SUPPLEMENTAL INFORMATION ADDENDUM NO. 1

PROJECT:	ITB No. 18-006 Blue Jay Road Water Main Extension
CONTACT:	Fiona Charleton, Purchasing Agent 912-754-2159 <u>fcharleton@effinghamcounty.org</u>
DATE ISSUED:	April 16, 2018

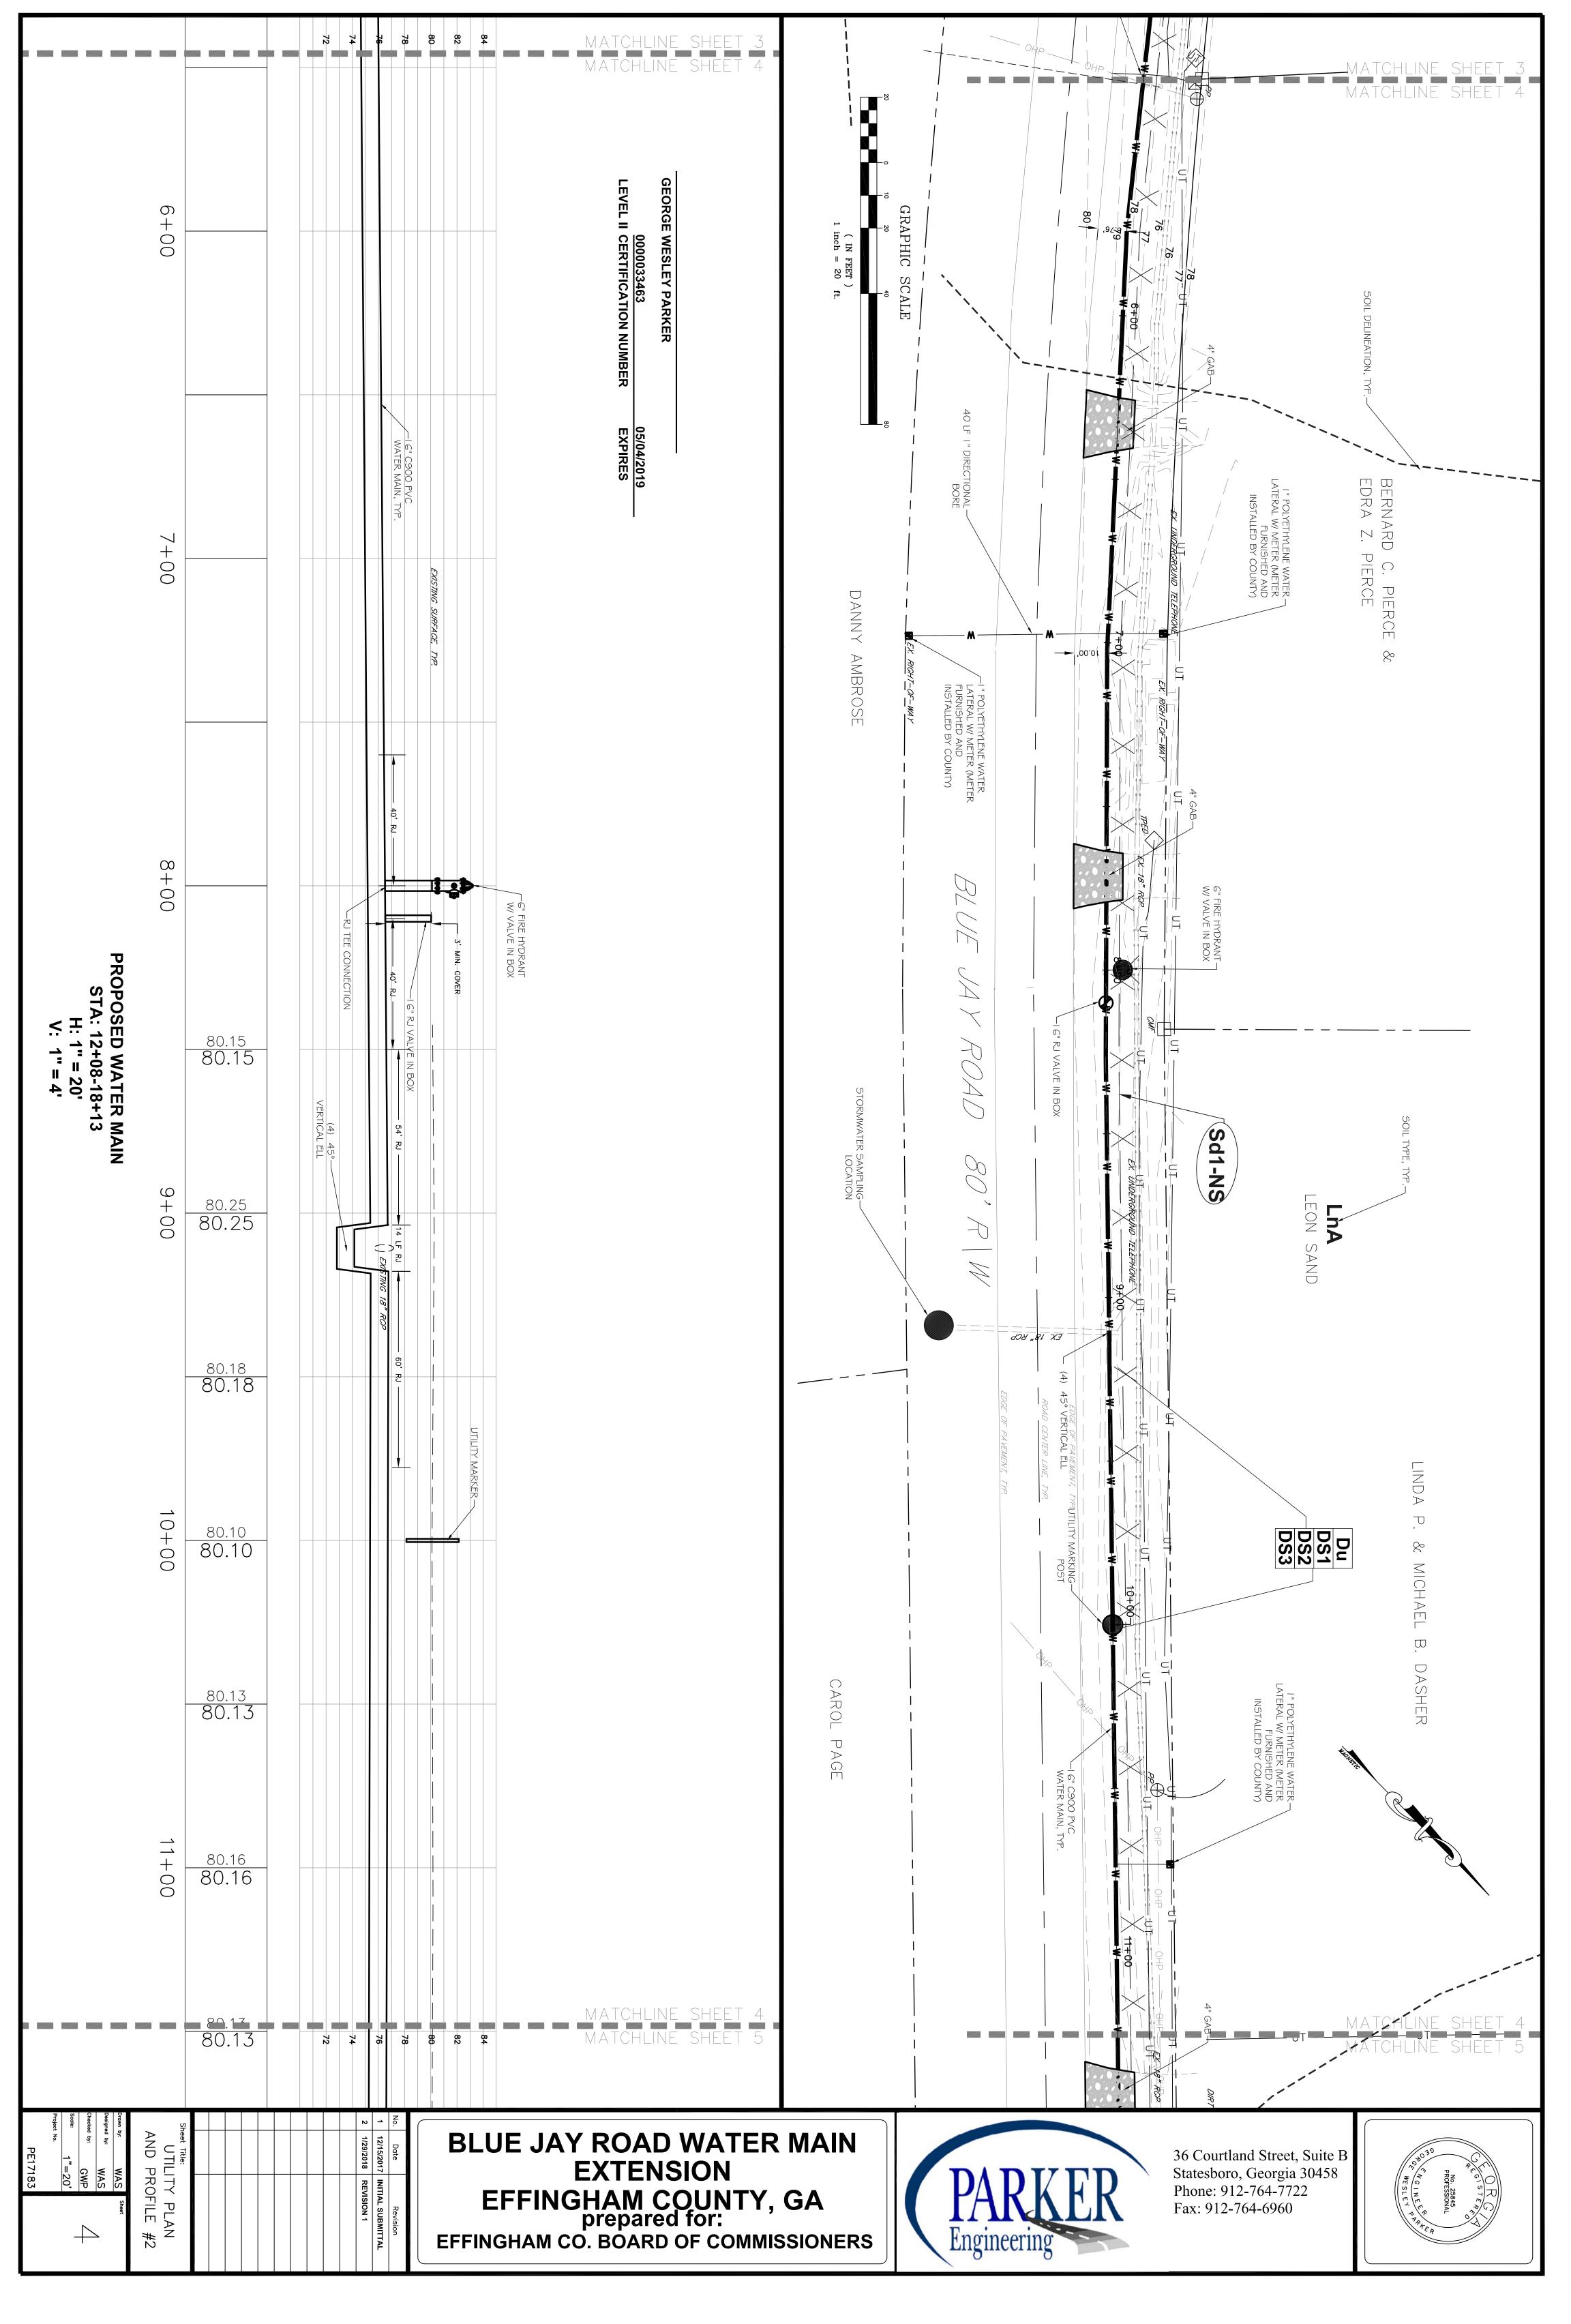
- 4) <u>QUESTION:</u> Continuing with bid items 10 & 11. Has the county contacted the respective utility owners regarding relocations or received an estimated cost of the same? <u>ANSWER:</u> The County's representative engineering firm, Parker Engineering, has contacted the respective utility owners and provided them with construction drawings. Neither owner has provided a cost estimate for potential relocations; however as per item #3, this becomes a moot point to the contractor.
- 5) <u>QUESTION:</u> The plans show a detail for the replacement of asphalt driveways but there is not a detail for the replacement of concrete drives. Could you please provide a concrete driveway detail? <u>ANSWER:</u> A driveway detail has been provided on sheet 14, included in this addendum.
